FINAL REPORT for the
PHASE I TIME-CRITICAL
REMOVAL ACTION
ACTIVITIES

at the Master Metals, Inc. Site

Cleveland, Ohio

RE: Master Metals Phase I Time-Critical Removal Comments

Figure 7-1
AREAS REQUIRING EXCAVATION

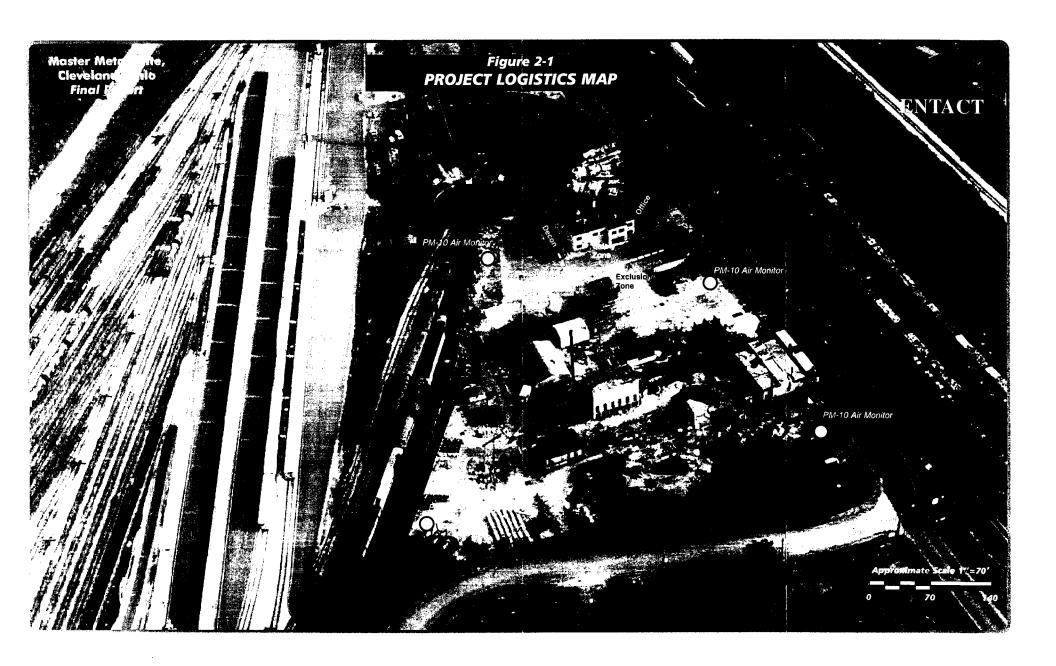
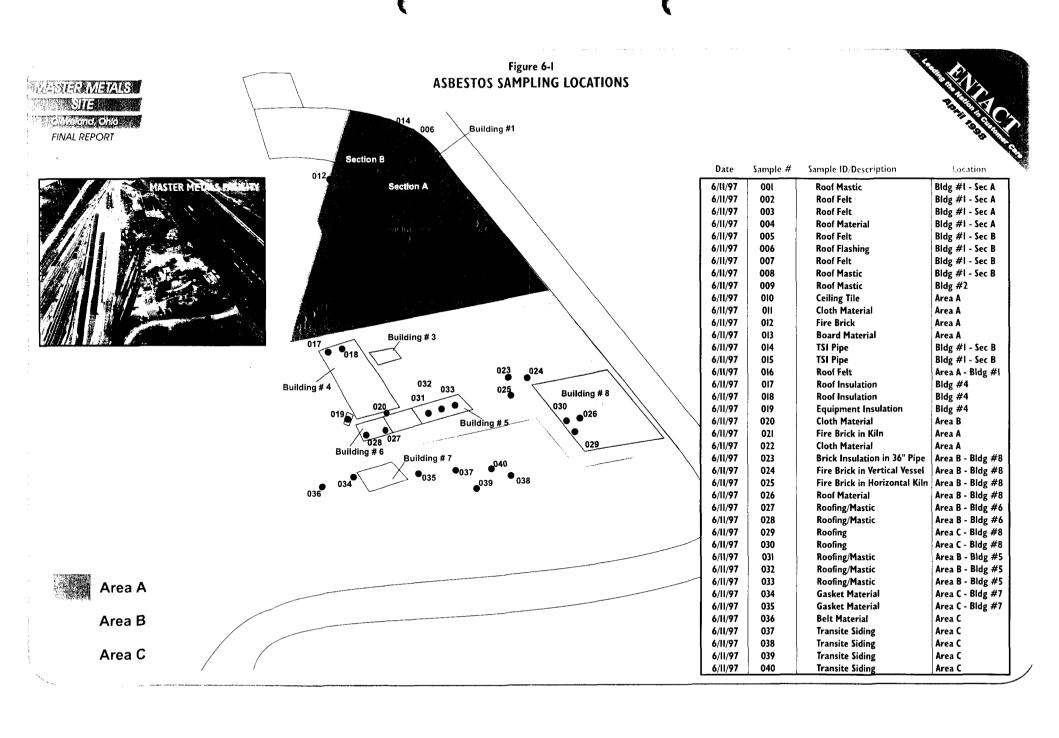
U.S. EPA Comment #7, Section 7.3.2 Laboratory Verification (Tables 7-1 and 7-2): Please clarify the discrepancy between the narrative and the tables with respect to the choice of the grids for laboratory verification of lead. According to the narrative, three samples were collected from the eleven grids found to contain native sand or gravel for laboratory verification (Table 7-2). However, one of the grids chosen for laboratory verification, Z1, is described in Table 7-1 as "black, brown, rust slag" and not native sand or gravel; please clarify why this specific grid was chosen. Also, please ensure grid correspondence between Table 7-1 and Figure 7-1.

ENTACT Response: The description of each grid represents the majority of material in that grid. However, grid Z1 was predominately slag. However, this grid also contained significant amounts of sand. Note that grids AA1 and BB1 also contain large quantities of sand. Therefore, this sampling location was chosen for sample collection.

In addition, Figure 7-1 has been clarified to more accurately reflect the data in Table 7-1.
